REQUEST FOR WRITTEN APPROVAL TO USE CONSTRUCTION METHODS NOT INCLUDED IN OREGON ADMINISTRATIVE RULES 690-200 THROUGH 690-240

#3- NW SW
(1) Location of Well #4- SE 1/4 NW 1/4 of Section 25

(2) Start Card Number(s): 141233 & 141232

- (7) Diagram showing the pertinent features of the proposed well design and construction (attach additional pages if needed):

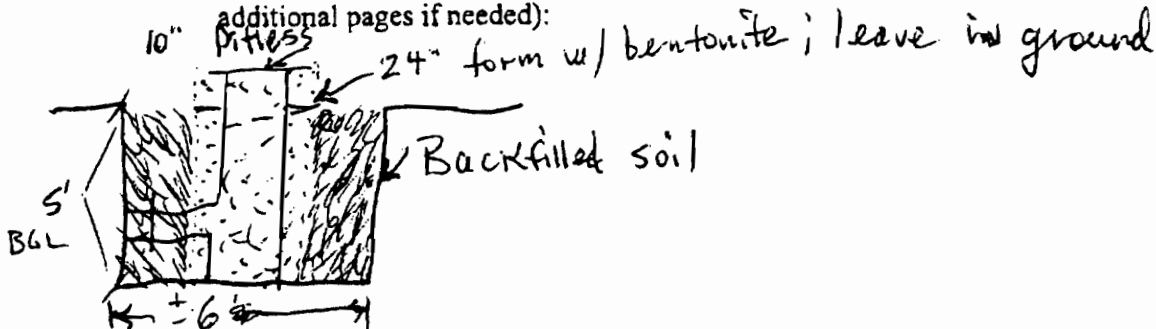
(5) The unusual conditions which necessitate this request: installation of a 10" weld-on pitless adapter necessitated a large pit around the casing to 5' BGL.

setting of a heavy cardboard cement-type form, 24" i.d., over the pitless & conduits, backfilling around the form with dirt & inside the form w/ dry bentonite, leaving the form in the ground.

Date: 11/26/02
Approved by: David J. Smith Denied by: _____
Remarks: Verbal approval given previously.
